Access Compliance Report

Public Rights-of-Way

(Curb Ramps)

Intersection ID: 12455	Main Street: W_3RD_ST	Cross Street: S_TRYON_ST	Location: W
ADA ID: F56374BDBFBC	Ramp Type: Perp	Initial Pass/Fail: Fail	Overall Compliance: No
		Severity Score: 22.5	
Codes/Mitigation Info/Possible Solution		Field Measurements/Component Compliance

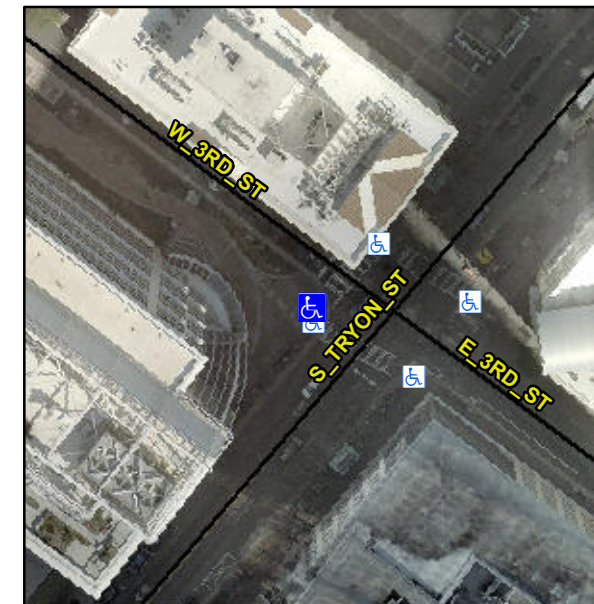
R304.5.1, R304.2.2, R304.5.3

Compliance	Description	Data	Compliance	Description	Data
N/A	Ramp Length (in)	24.0	No	Ramp Slope (%)	9.0
No	Ramp Width (in)	41.0	No	Ramp XSlope (%)	2.2
N/A	Flare Type LT	N/A	N/A	Flare Type RT	N/A
N/A	Flare Slope LT (%)	N/A	N/A	Flare Slope RT (%)	N/A
N/A	Flare Traversable LT?	N/A	N/A	Flare Traversable RT?	N/A
N/A	Landing Length (in)	N/A	N/A	DWS Provided?	N/A
N/A	Landing Width (in)	N/A	N/A	DWS Contrast?	N/A
N/A	Landing Slope (%)	N/A	N/A	DWS Length (in)	N/A
N/A	Landing X Slope (%)	N/A	N/A	DWS Full Width?	N/A
N/A	Landing Curb? (Y/N)	N/A	N/A	DWS Offset (in)	N/A
N/A	Shared Landing?	N/A			
N/A	Gutter Ponding?	N/A	N/A	Gutter Slope (%)	N/A
N/A	Gutter Lip Ht (in)	N/A	N/A	Gutter X Slope (%)	N/A
N/A	Painted X Walk1?	Yes	N/A	Painted X Walk2?	N/A
	X Walk 1 Direction	To NE		X Walk 2 Direction	N/A
N/A	X Walk 1 Width (in)	118.0	N/A	X Walk 2 Width (in)	N/A
	X Walk 1 Slope (%)	2.5		X Walk 2 Slope (%)	N/A
	X Walk 1 X Slope (%)	2.1		X Walk 2 X Slope (%)	N/A

Remove & Replace Entire Ramp.
